## Difference of Declaration

We, the undersigned **Wyze Labs, Inc**, hereby declare the difference between HW:V1.3 and HW: 1.4 are as below:

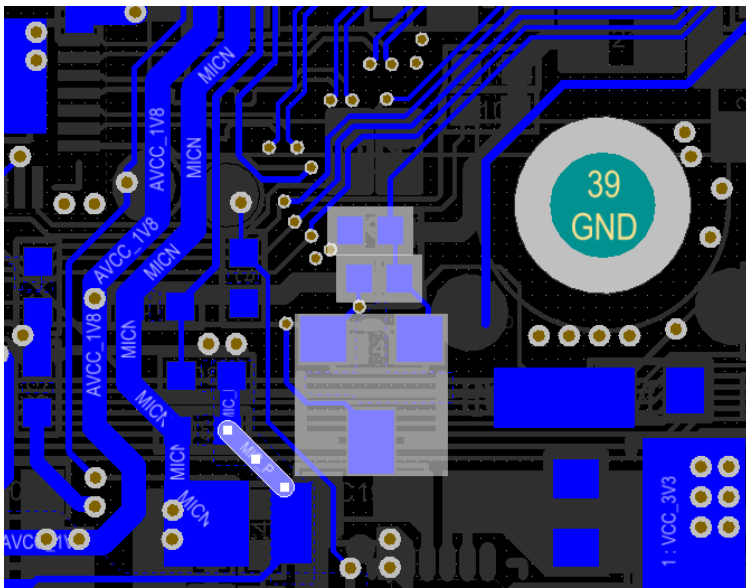
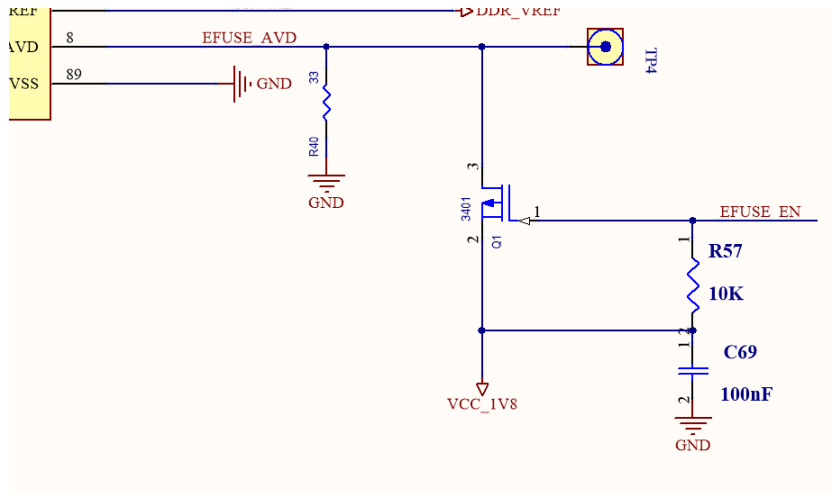
V1.4 Schematic diagram: add MOS tube, resistance and capacitance to external circuit.
